PARACHUTES AUSTRALIA

SERVICE BULLETIN No PA SB9202

SUBJECT: PA SLIMPACKS AND THINBACKS WITH RAPIDE LINKS

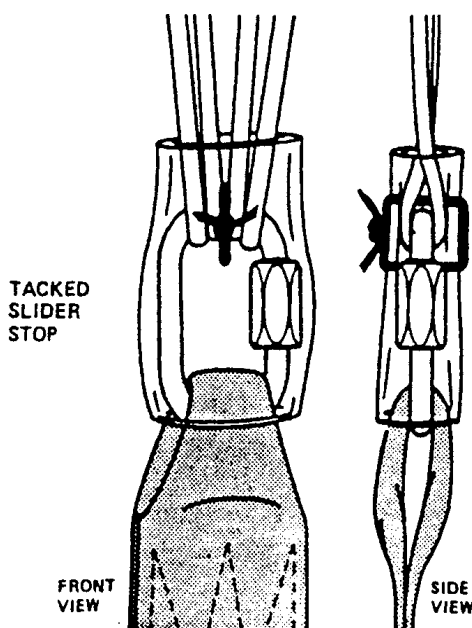
BACKGROUND: The Royal Australian Air Force uses the T103 Parachute for emergency aircrew use. It has been established that No. 6 Rapide links can rotate sideways on the risers and/or pull threads on braided rigging lines.

MANUFACTURER ADVISORY: All Slimpack and Thinback Parachutes in service which use the No. 6 Rapide link should have PVC or Silicon rubber tube fitted over the links as illustrated.

Note: It is important that if PVC or loose Silicon tube is used it be tacked to the Rapide link so it does not slide up the lines and cause a malfunction.
